A Landowner's Perspective on COHYST

Ronald D. Klein, PE

October 23, 2003

Water Level - 1932 - 2002 **Original Well G-101788**

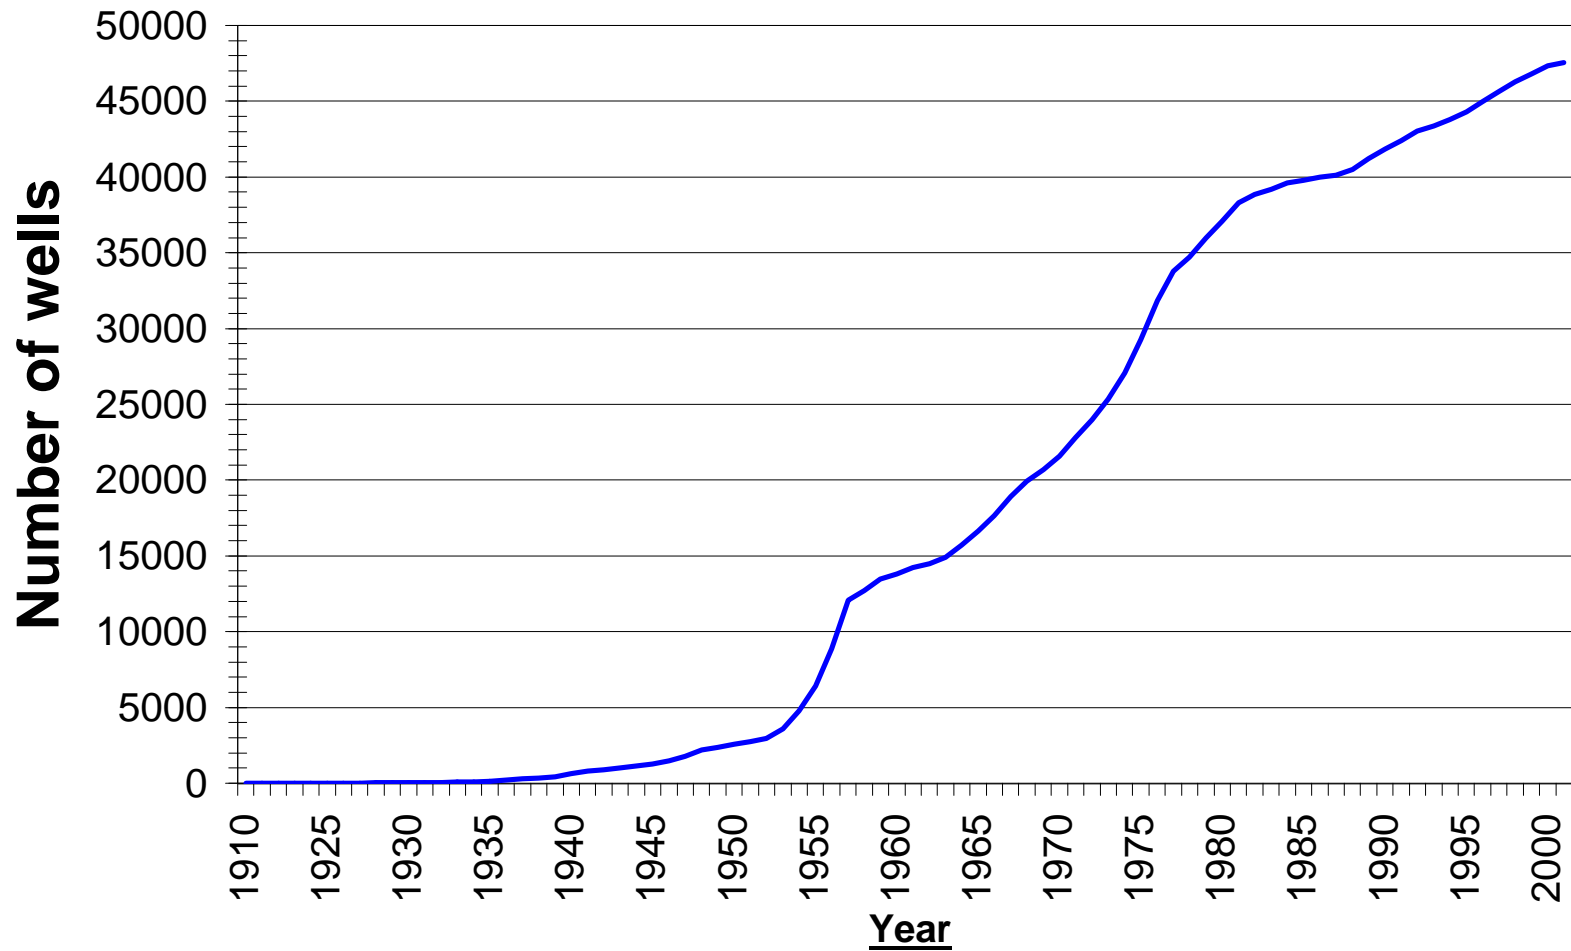
- Search led to:
 - “The Myth of Platte River Water Depletion - A Work in Progress” by 2 NPPD employees (Kwapnioski/Dekleva)
 - Found credible flow data on USGS web site
 - Well count data from Duane Woodward
 - Water level data from DNR back to 1932 - (my own well!)
- Analysis (1st order) showed:
 - No apparent decline in water level over the **long term**
 - River flows actually increased beginning in early ‘70’s
 - By that time well count increased from 1,000 to more than 47,000
- **Doesn’t it seem that?:**
 - If well use is depleting river, with this large an increase in groundwater use, that there would be some flow impact evident?
 - If water tables were dropping - LONG TERM - that you would see it over 70 years?

— Measured
— 70 yr avg -12.5 ft
